# PREVOST

## SAFETY RECALL

Sr11-10

| SUBJECT : REPLACEMENT OF THE FUEL TANK SUPPORT |                   |

APPLICATION OF SELF-ADHESIVE NEOPRENE FOAM (dark area)

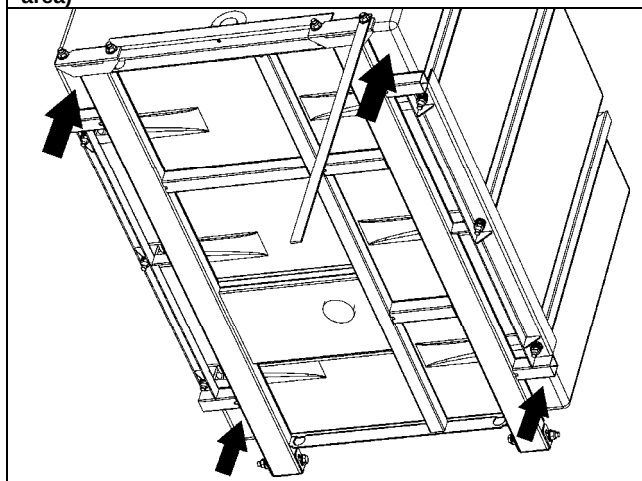
3. Apply self-adhesive neoprene foam (p/n 506758) on the new platform as shown.
4. Lift the vehicle.

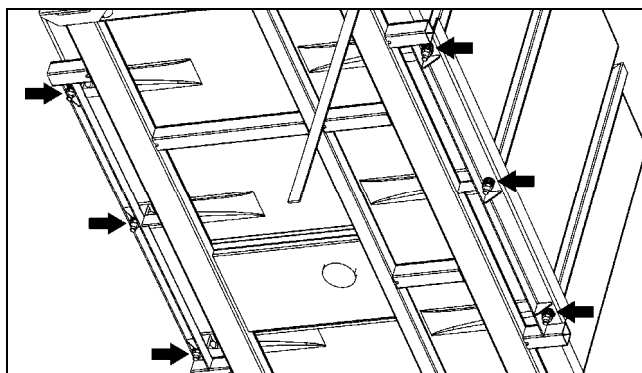
5. Using four jack stands, support the fuel tank at the four corners as indicated on the image.

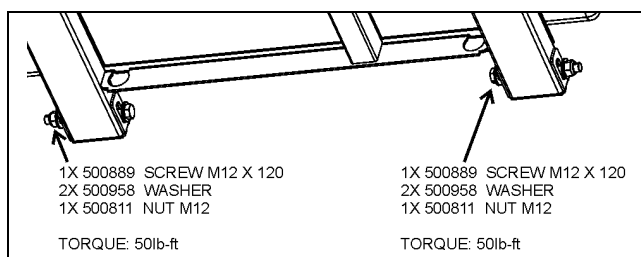
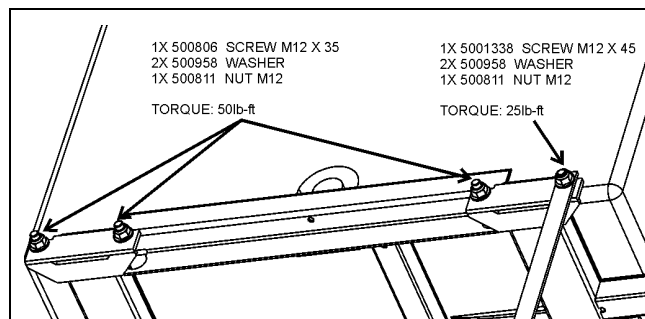
6. Unscrew the 6 tank retainer nuts.

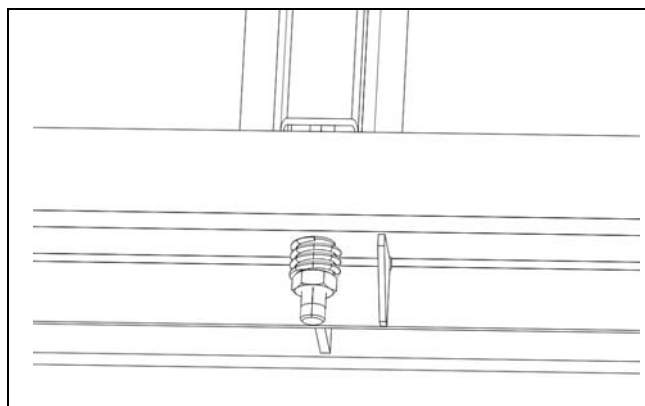
7. Unscrew the bolts (6) holding the fuel tank support to the vehicle chassis.
8. Replace the existing fuel tank support with the new one. Identify the defective support so it will not be reuse.
9. Install the new support with **new** hardware (bolts, washers and nuts).
  - Tighten bolts to 50 lb-ft (5 bolts)
  - Tighten bolts to 25 lb-ft (with static wick)
